October, 2021

ORIENTAL MOTOR CO., LTD.

[Important Notice] Notice and Request Concerning the Safety of Our Motor Driver

[Table-1] Names of applicable products

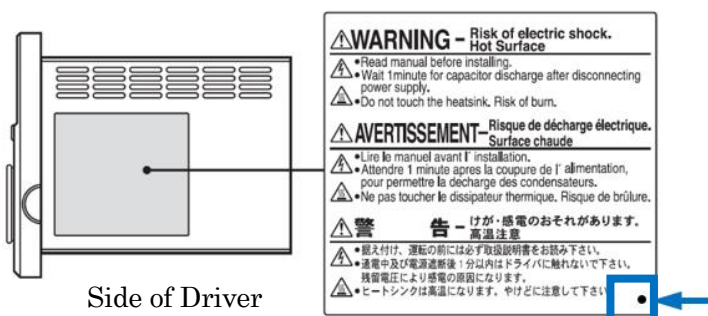
Please check the information on the nameplate located on the side of the product.

Applicable product meets all three of the following conditions.

- 1) The product name is listed in [Table-1].
- 2) “●” (a black dot) is found.
- 3) Combination of the first and second letters of the serial number is listed in
